ENGLISH BAZAR MUNICIPALITY
CONSTRUCTION SITE SECOND VISIT REPORT

Second Visit | PROP-00495 - A C Institution block 1

| Name of the Location | Latitude & Longitude | Ward | Area | Area Unit |
|-------------------------|--------------------------|------|-------|-----------|
| A C Institution block 1 | 22.5797202 88.4135331 | 11 | 23.25 | Sq/Meter |

Overall Work Status - Images

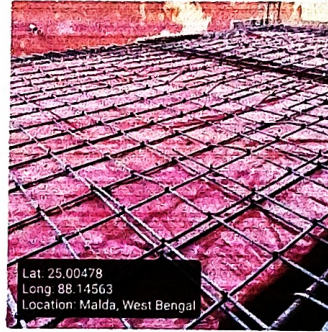
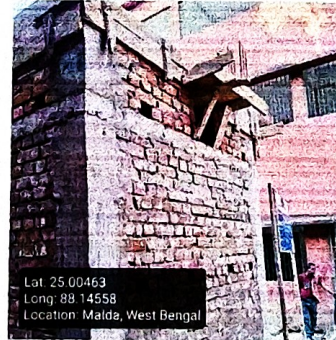
The brickwork between the lintel level and the rooftop has not been executed as per specifications and requires rectification.
